29/8/19 (1)
B6 Cwing
GROUND FLOOR

CASA OLIVIA (B6)

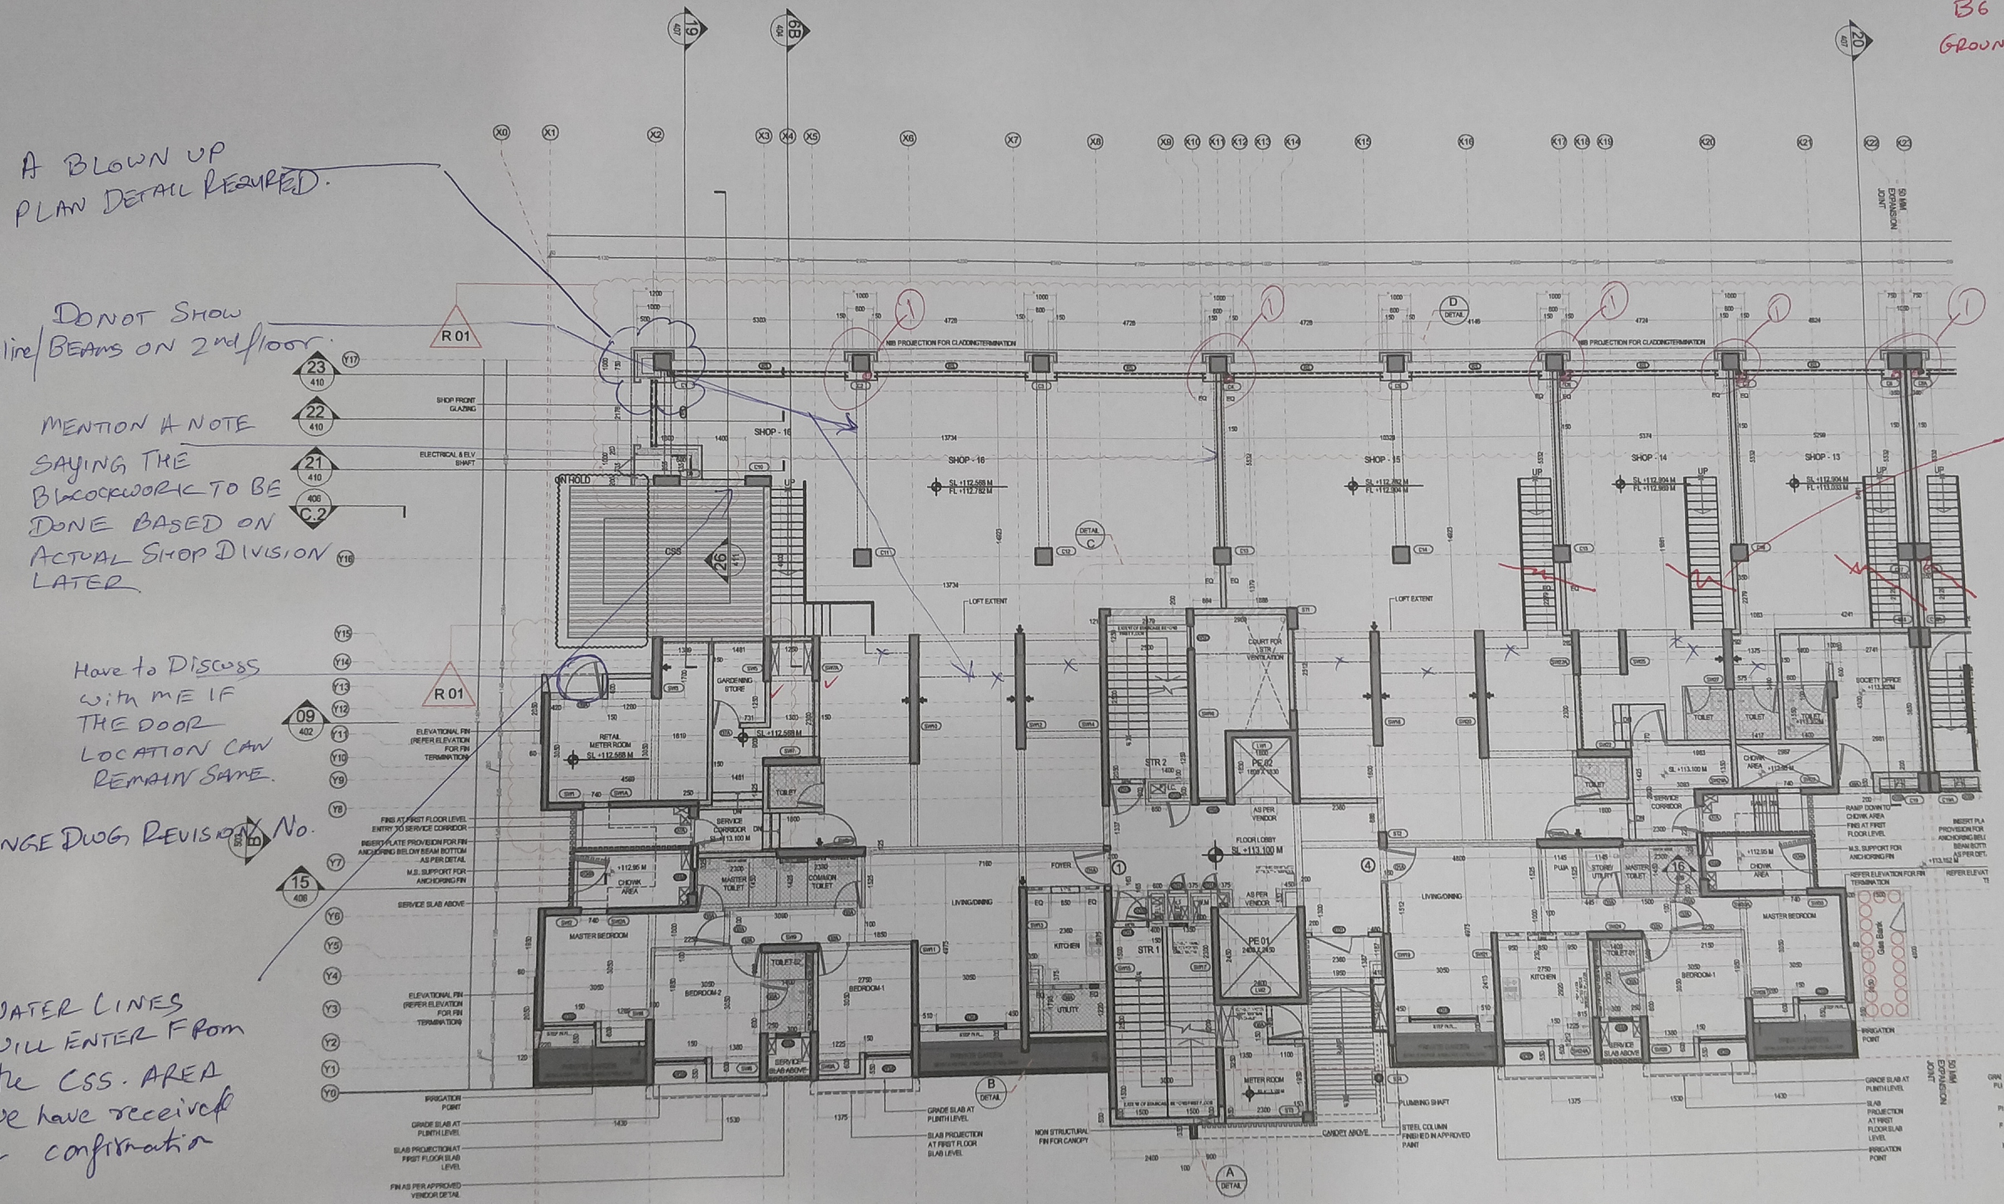
A BLOWN UP PLAN DETAIL REQUIRED.

DO NOT SHOW BLDG line/ BEAMS ON 2nd floor.

MENTION A NOTE SAYING THE BLOCKWORK TO BE DONE BASED ON ACTUAL SHOP DIVISION LATER.

Have to Discuss with ME IF THE DOOR LOCATION CAN REMAIN SAME.

CHANGE DWG REVISION No.

WATER LINES WILL ENTER FROM the CSS. AREA we have received the confirmation

SHOW CUT LINES & REST PORTION IN DOTTED.

29/8/19 (2)
B6 'A' wing
GROUND FLOOR

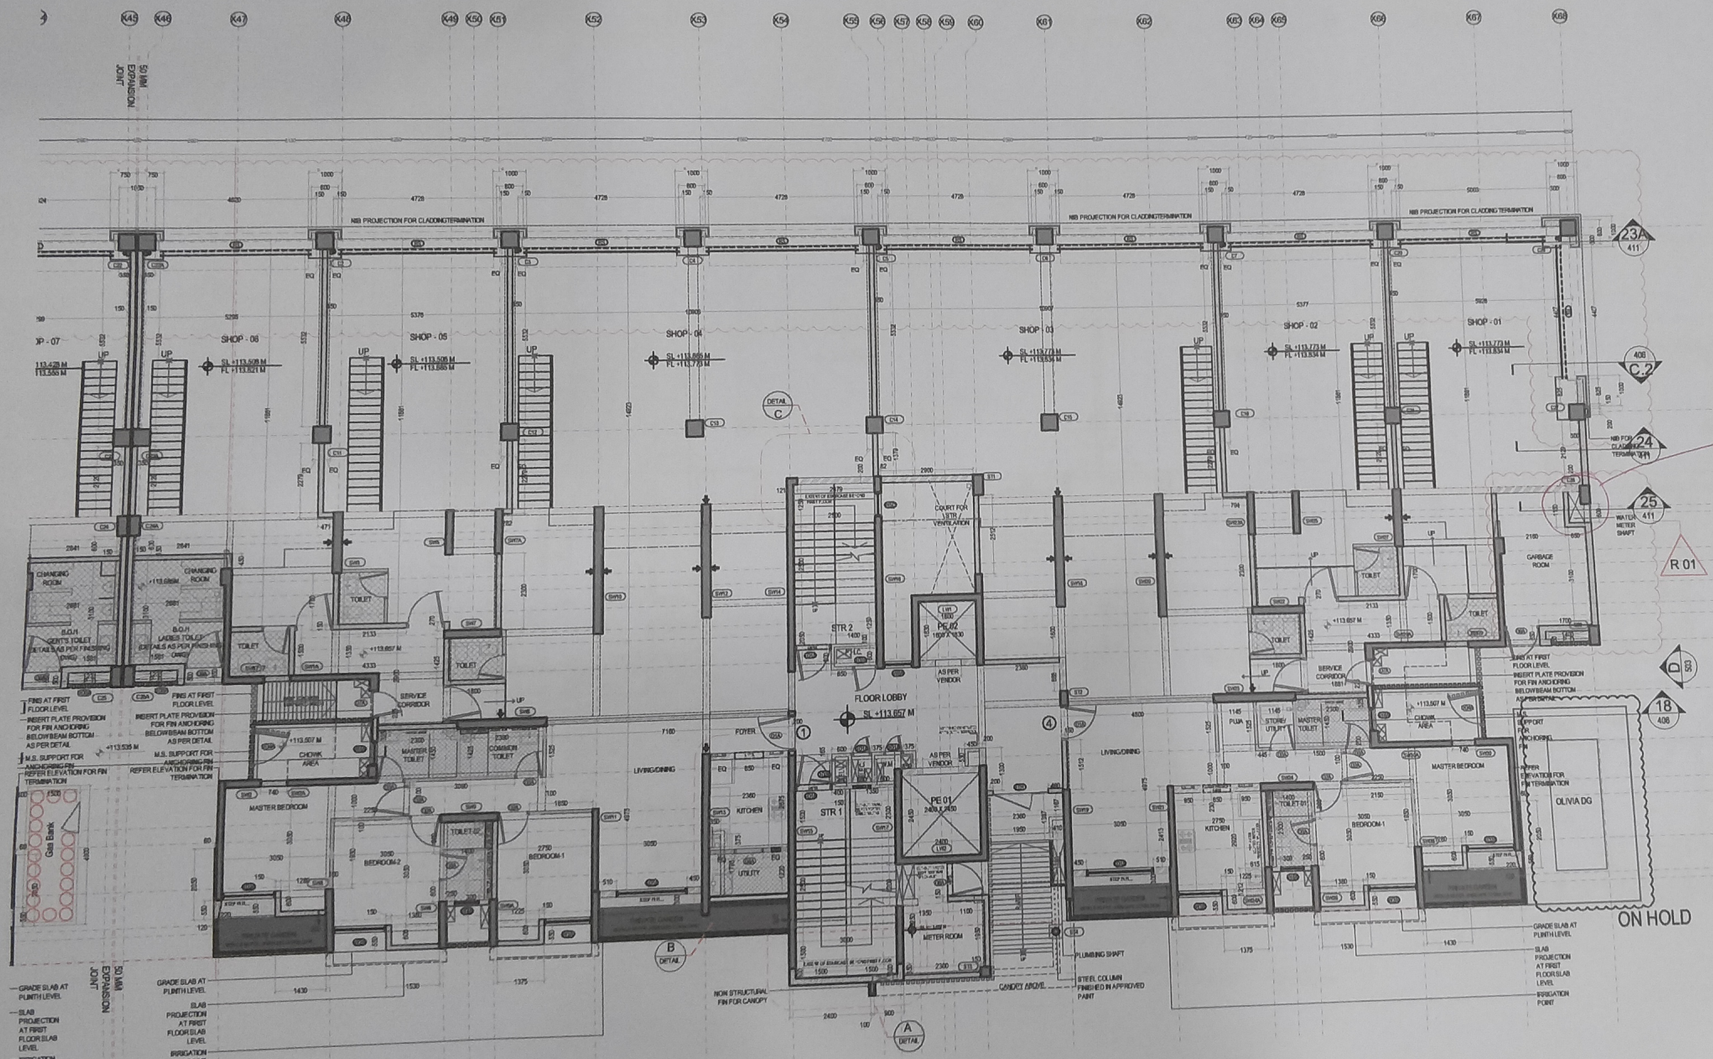
SHOW DOTTED BEAM ON 2ND FLOOR.

29/8/19 (3)
'B6'
FIRST FLOOR

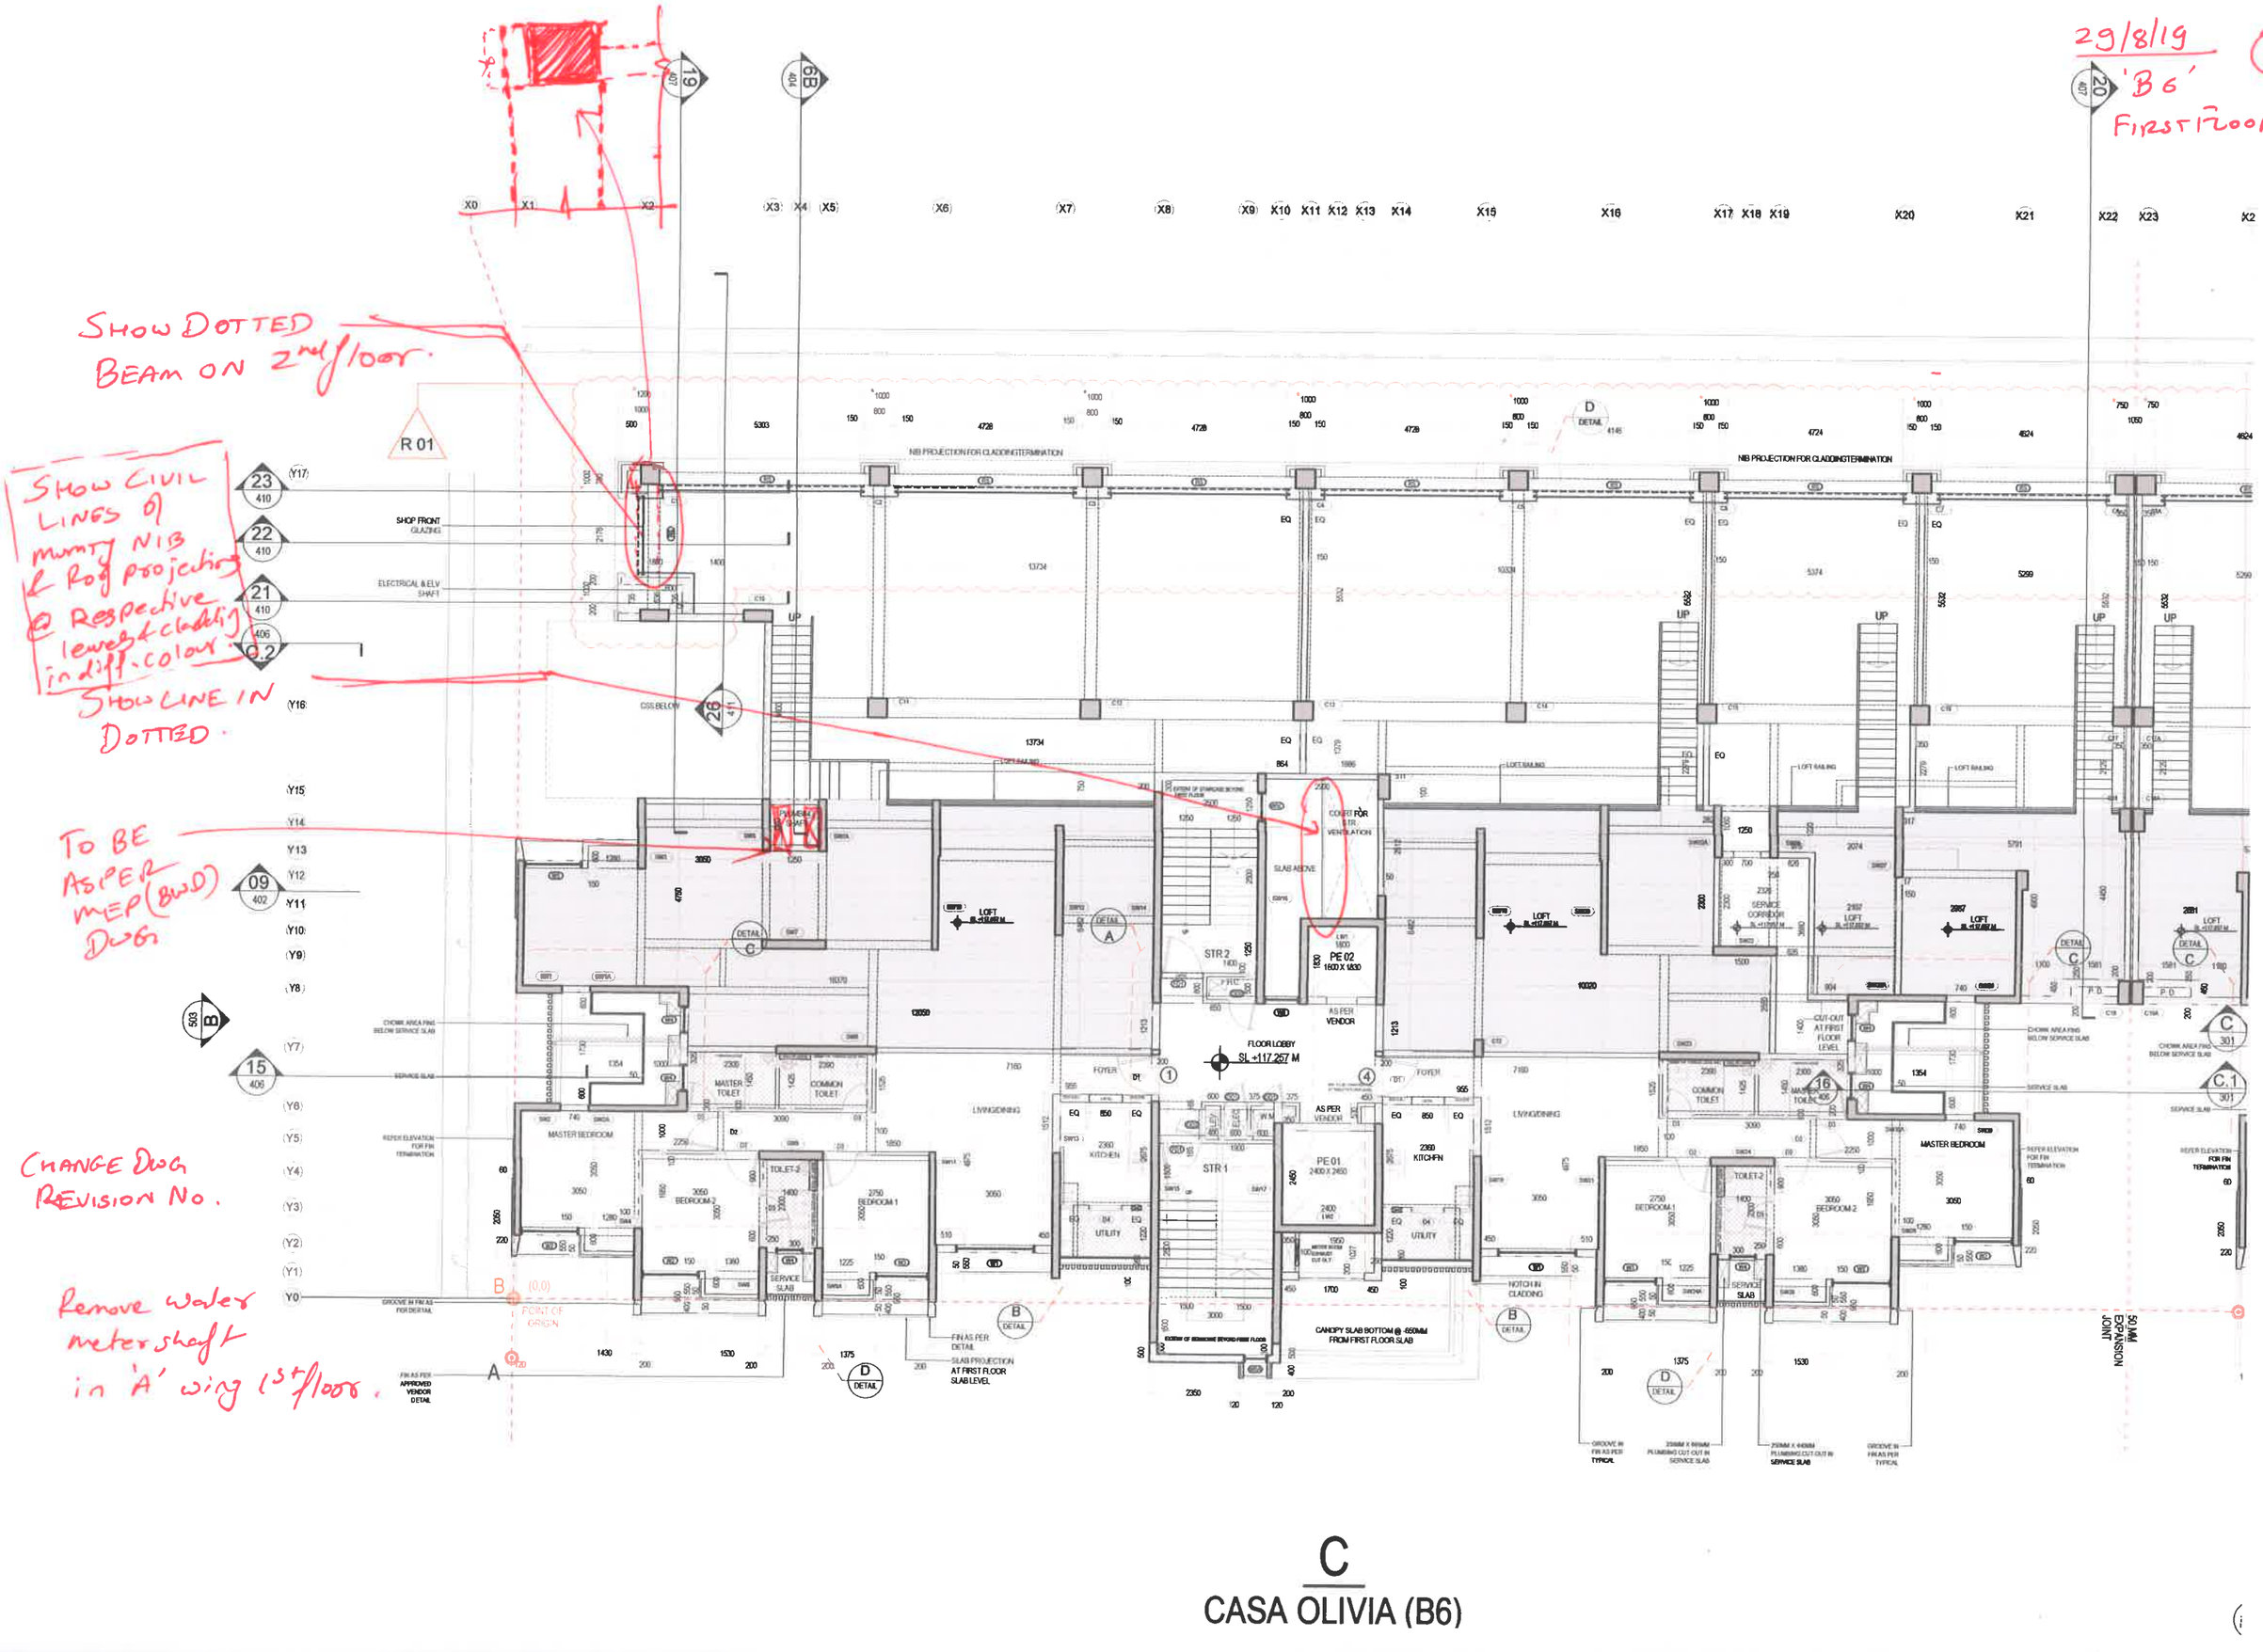
SHOW CIVIL LINES OF MUNTY NIB & RCP PROJECTION @ RESPECTIVE LEVELS & CLADDING IN DIFF. COLOUR.

SHOW LINE IN DOTTED.

TO BE AS PER MEP (BWD) DWG

CHANGE DWG REVISION NO.

Remove water metershaft in 'A' wing 1st floor.

The Mumty Blockwork to be either - 150/200
